Clash Publish

Clash Computation Specification			
Products Selected		Value	Status
AT672137MQ - C-TO-C Alignment Sec.11, Side A	AT602161MQ- MUON BARREL CHAMBERS DETAILED – SECTOR 11	-49.9 mm	Not Relevant

Revised by Philippe Schune 29/07/2005

Clash View:

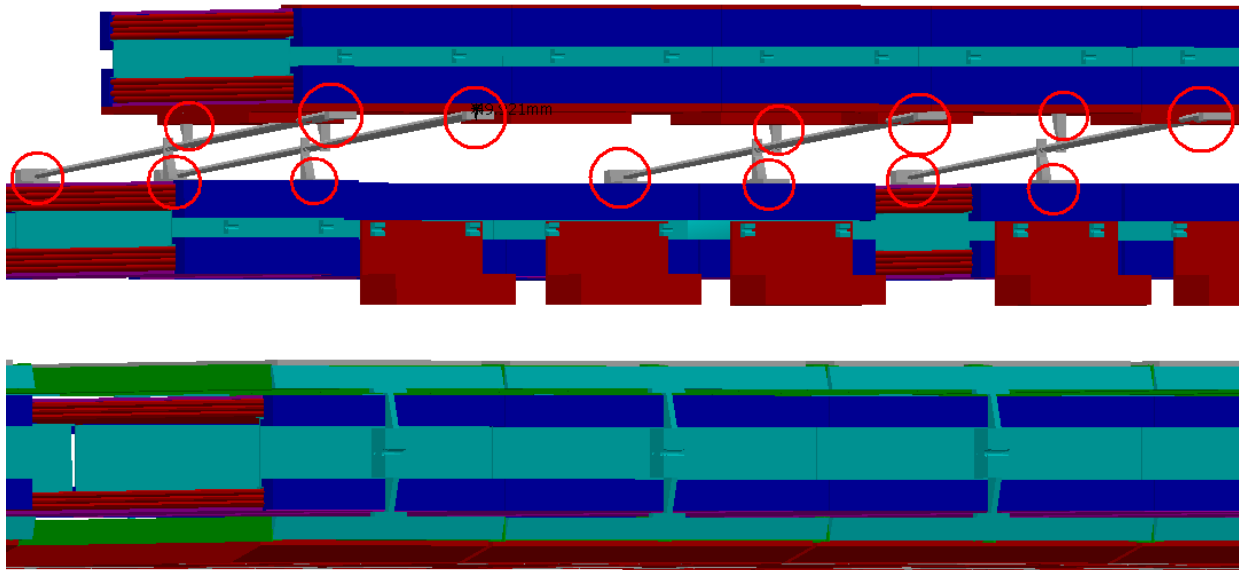
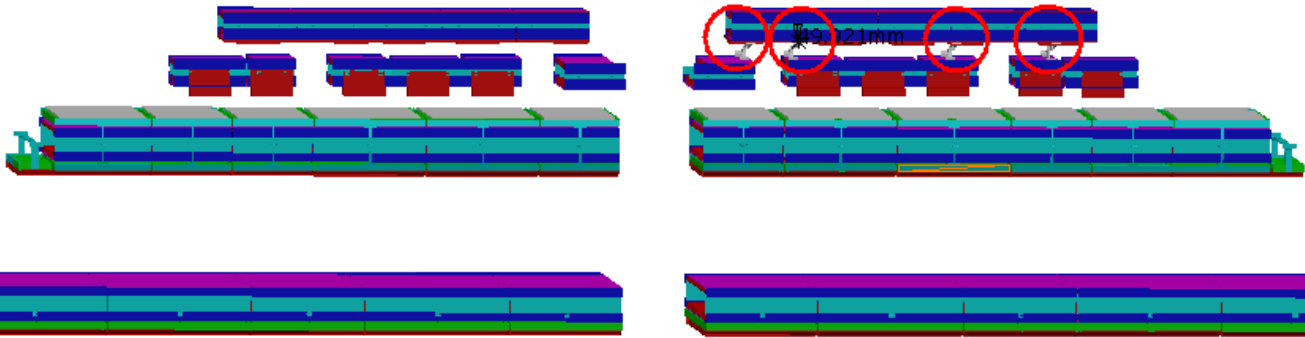
AT672137MQ - C-TO-C Alignment Sec.11, Side A	AT602161MQ- MUON BARREL CHAMBERS DETAILED – SECTOR 11	Clash	-49.9 mm	Not Relevant
---	--	-------	----------	--------------

Philippe: I have checked boxes and they are split. So, conflict doesn't exists but model have to be updated

Clash value: ~ -49.9 mm
